Technical Service Bulletin

50E6 UPDATE – Vehicle Emissions Control Information Label (FED_EMS)

March 12, 2019

Model(s)	Year	VIN Range	Vehicle-Specific Equipment
A4 and A5	2019	See Campaign/Action screen in Elsa	None

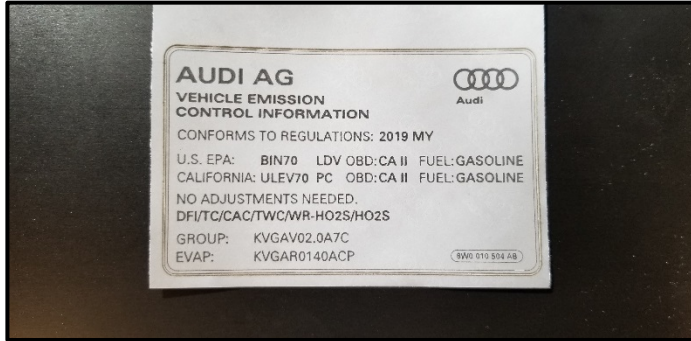
Currently installed VECI labels contain an error in the 5th character position of the test group, KVGAJ02.0A7C. Updated VECI labels replace the J with a V in the 5th character position, correcting the test group to KVGAV02.0A7C. This Update is in effect until removed.

- Open hood.
- Locate the Vehicle Emissions Control Information Label.
- Clean the Vehicle Emissions Control Information Label and surrounding area as necessary to remove any dirt or debris.
- Remove the paper backing from the new label, align new the label on top of the old label, and apply the new label to the vehicle.

- The surface of the existing label must be clean, dry, and free from oil residue prior to applying the replacement label.
- The replacement label **MUST** cover the existing label completely.
- Handle the replacement label carefully. Do not touch the adhesive backing.
